December 8, 2023

Subject: Engineering Peer Review
 Ocean Pines Condominium Development – Lot 61
 Bourne, MA
 CEC Project 335-785

SITE PLAN
 FOR
WILDWOOD LANE
 BOURNE, MASSACHUSETTS

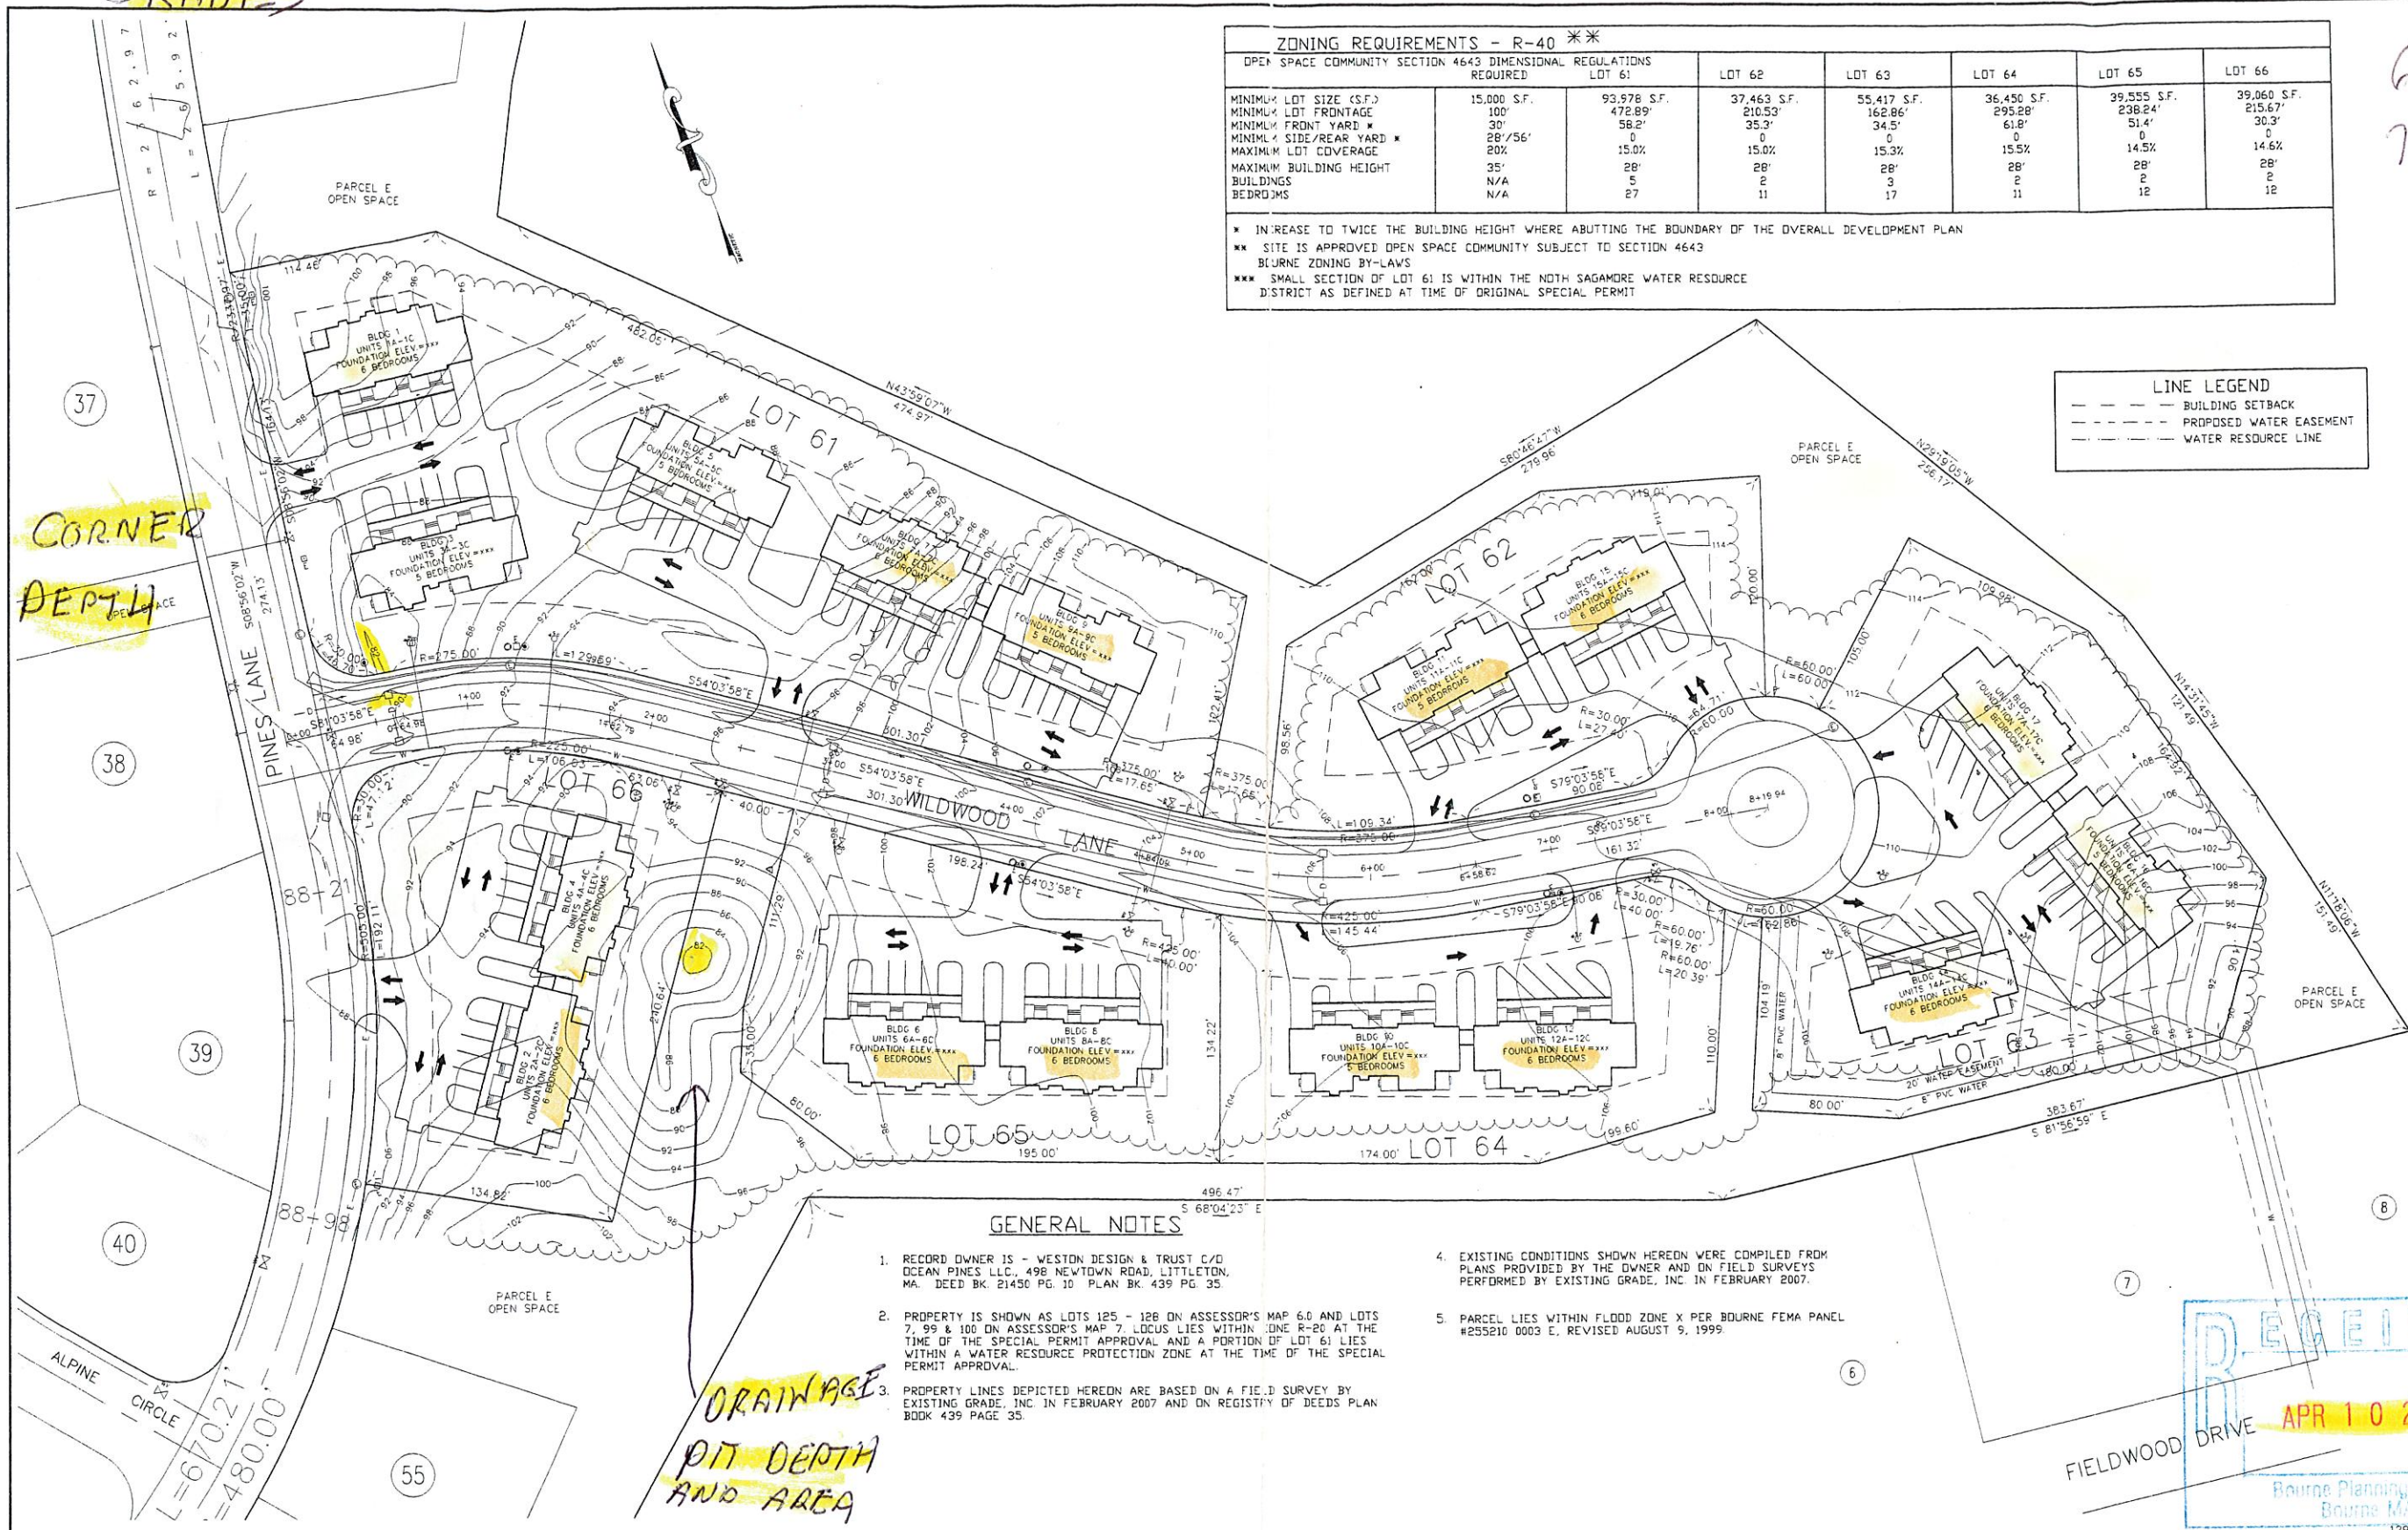
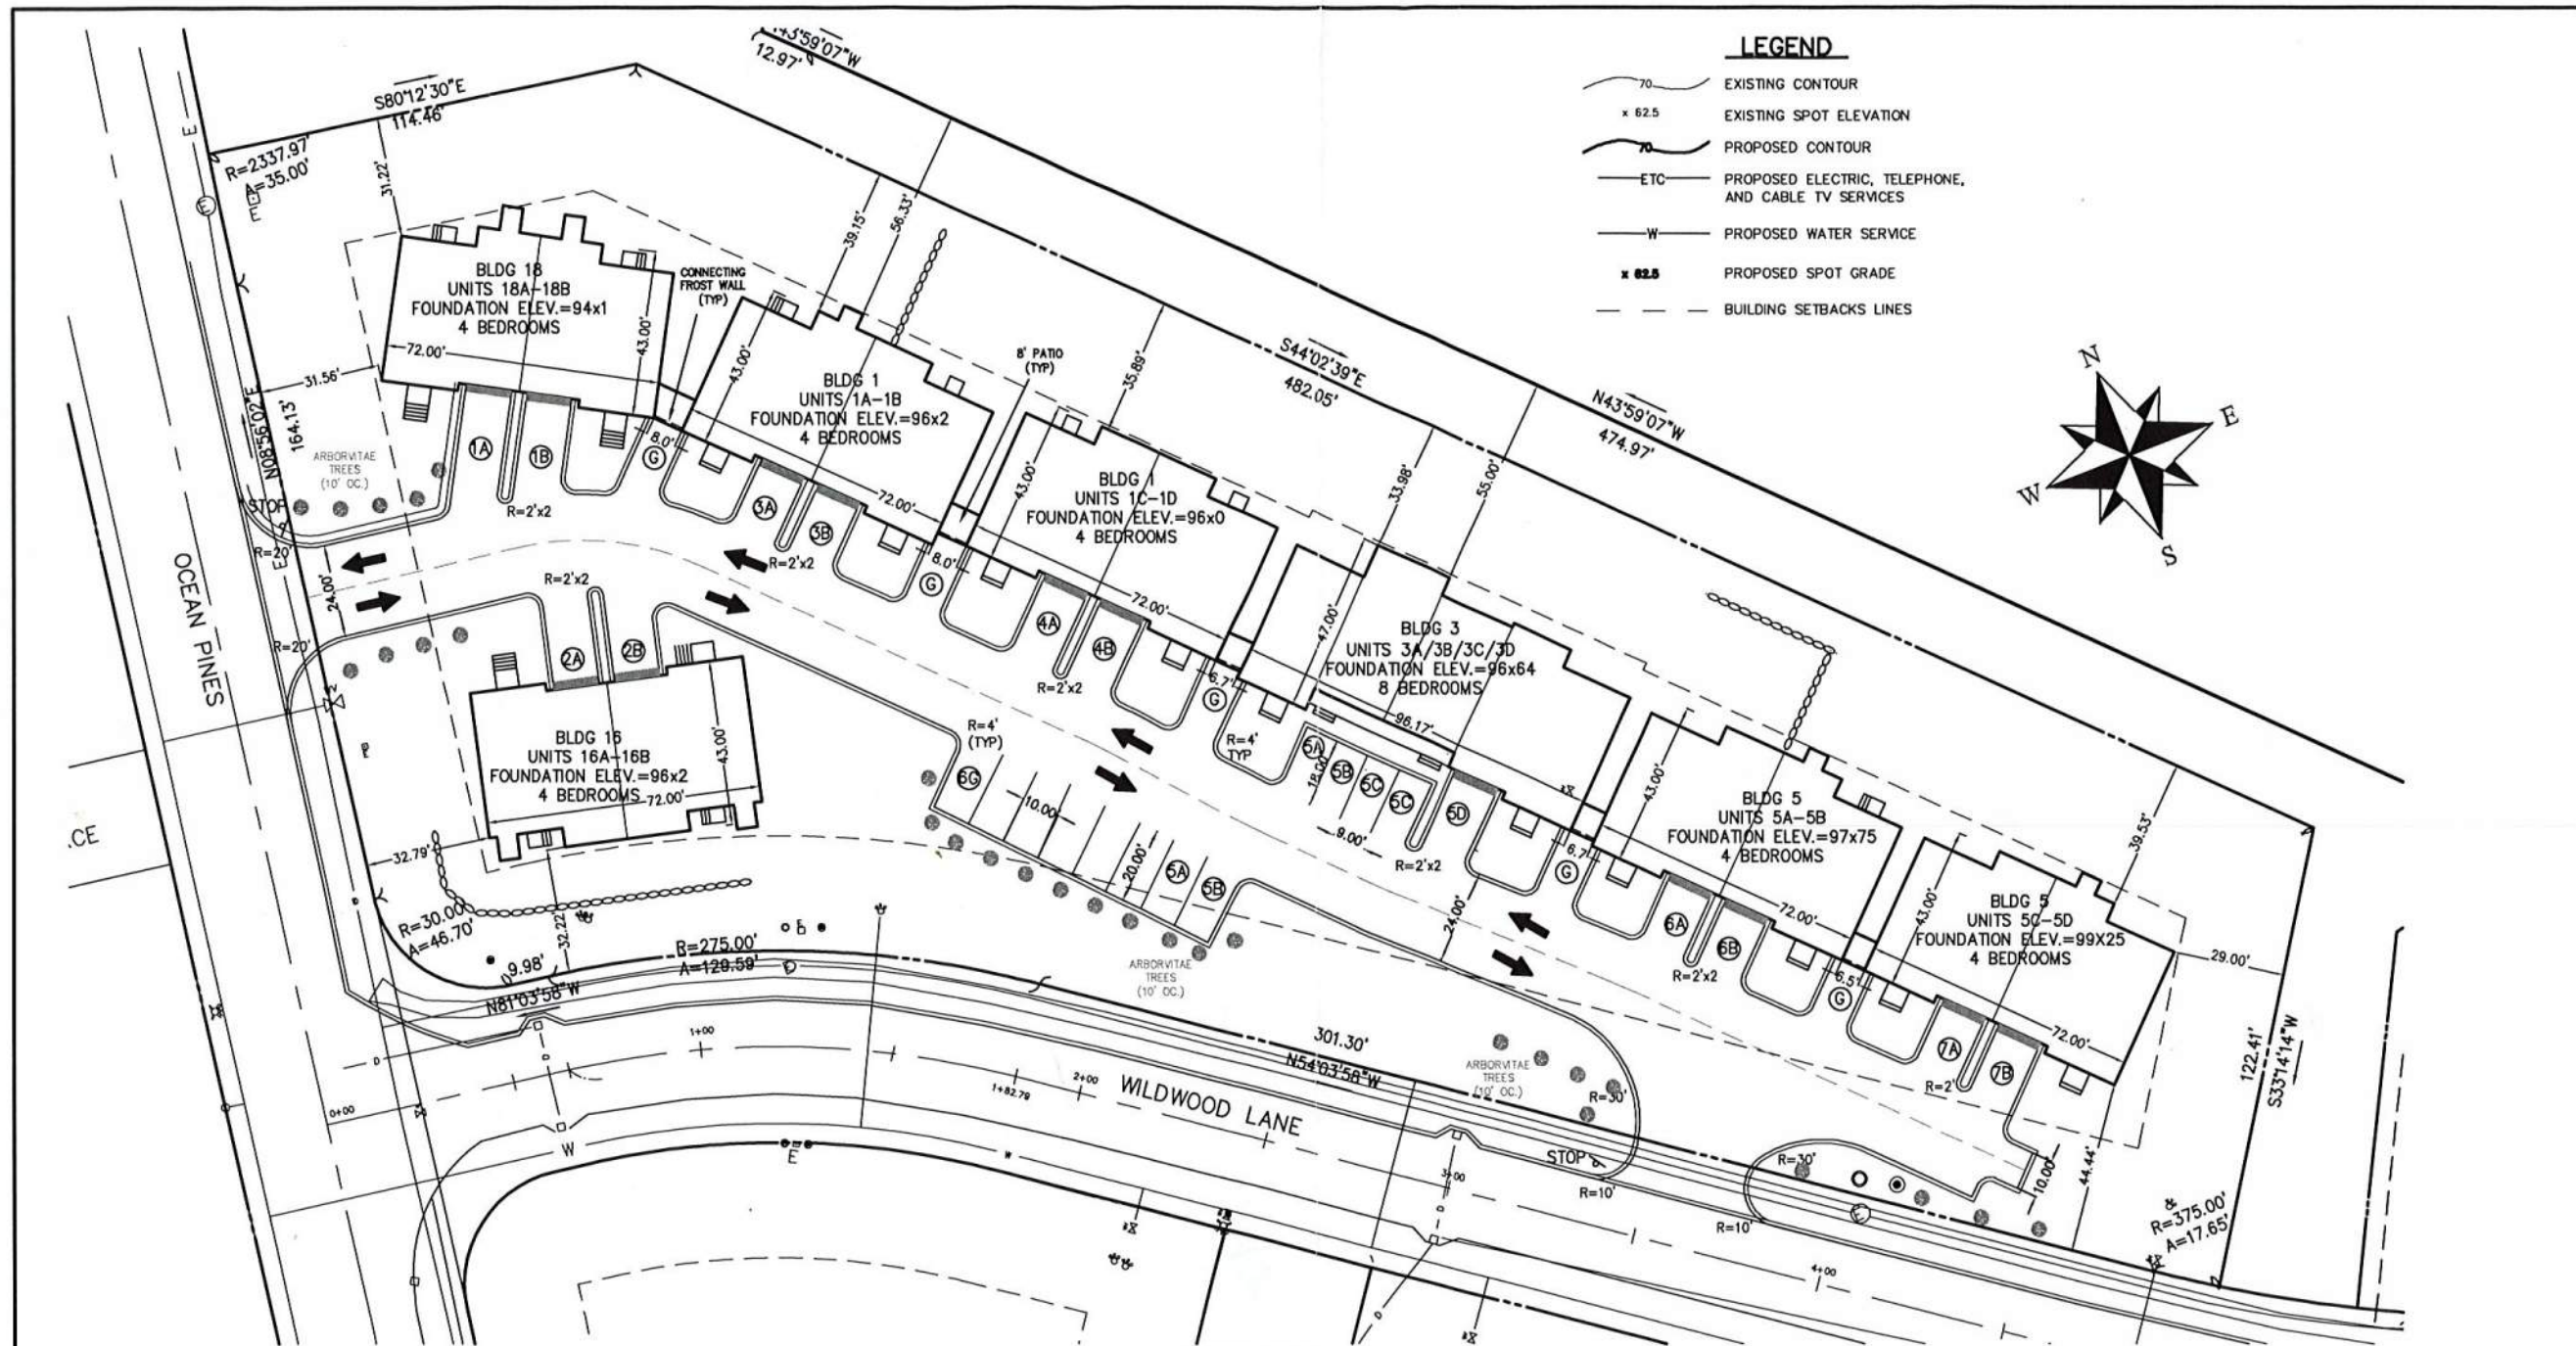
- The current development includes numerous deviations from the design included in the original 1987 Special Permit Approval. Additionally, the current Site Plans for the development of Lot 61 appears to be significantly different from the subsequent design as depicted on the 2007 Plan. These should be reviewed for conformance with the original permit approval and if additional review and approvals by the Town Planning Board is warranted.

PROPOSED
SEPTIC/GRADING LAYOUT PLAN
61 WILDWOOD LANE
BOURNE, MA

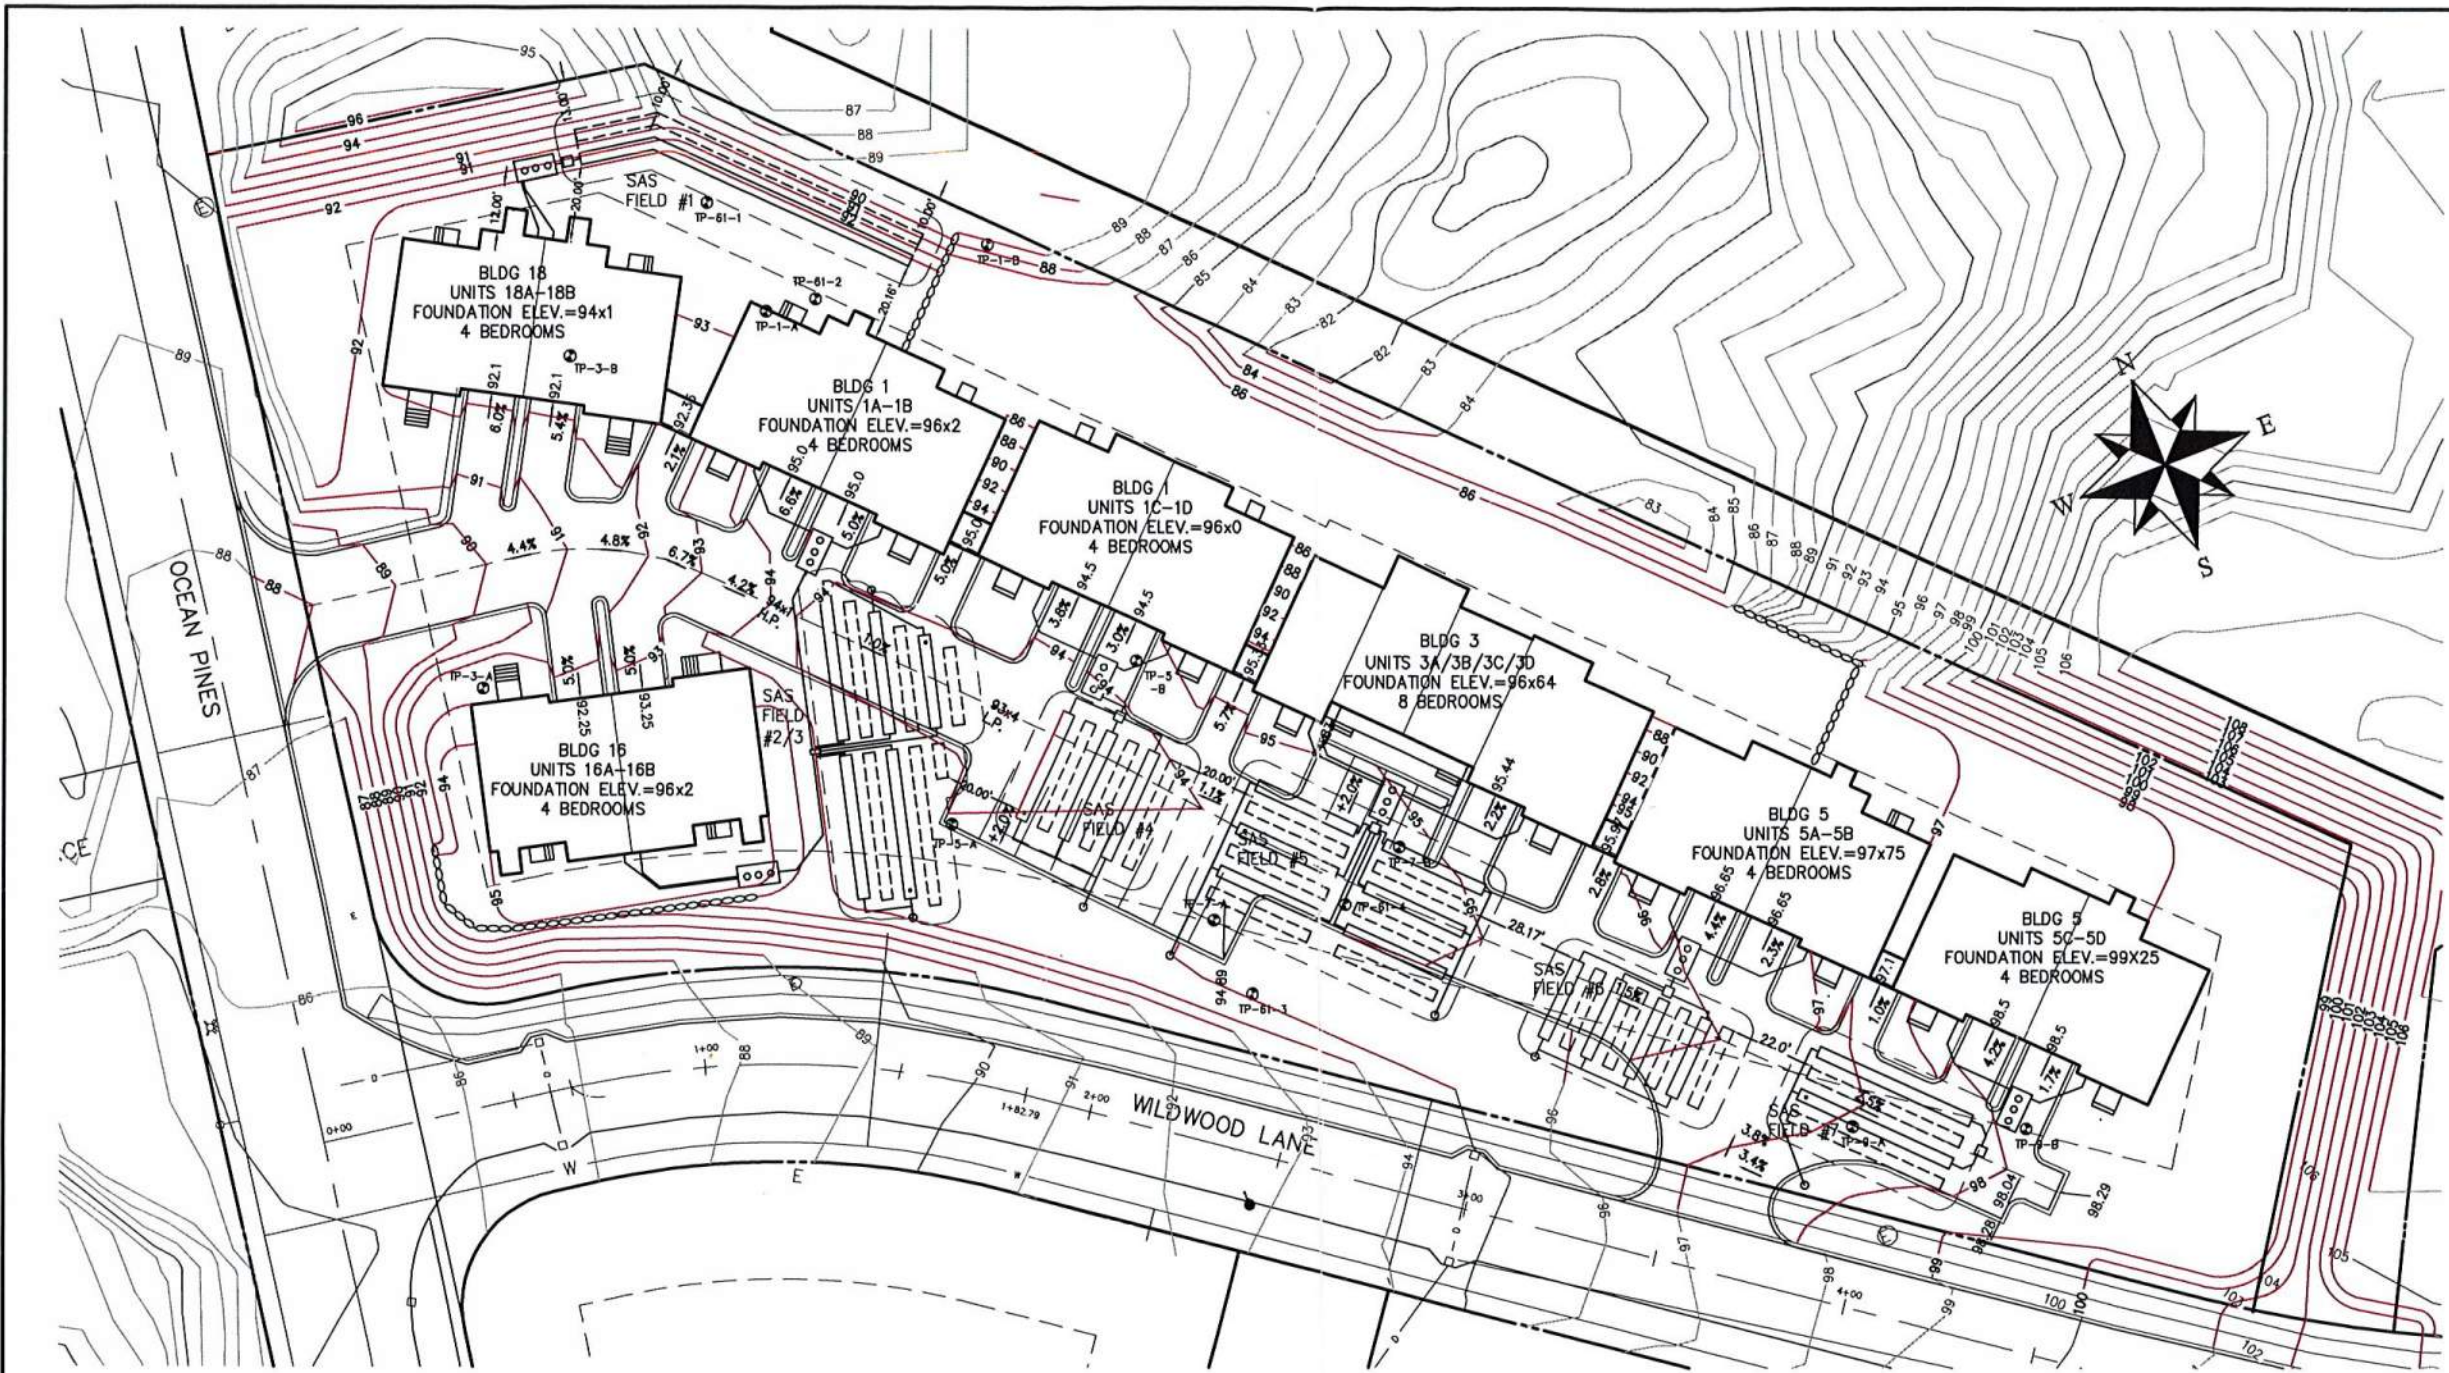
- The Proposed Septic/Grading Layout Plan from the Lot 61 Plans appears to identify a low point at Elevation 91-ft behind Building 18 with no apparent outlet. Additional information should be provided confirming how this area will drain.

- The Proposed Septic/Grading Layout Plan from the Lot 61 Plans identify that Building 16 is proposed with a Finished Floor elevation approximately 10-ft higher than the adjacent Wildwood Lane roadway grade. This may result in the building feeling very imposing on the adjacent roadway. CEC recommends that this condition be reviewed to confirm the building design and height conform with Town requirements and regulations.
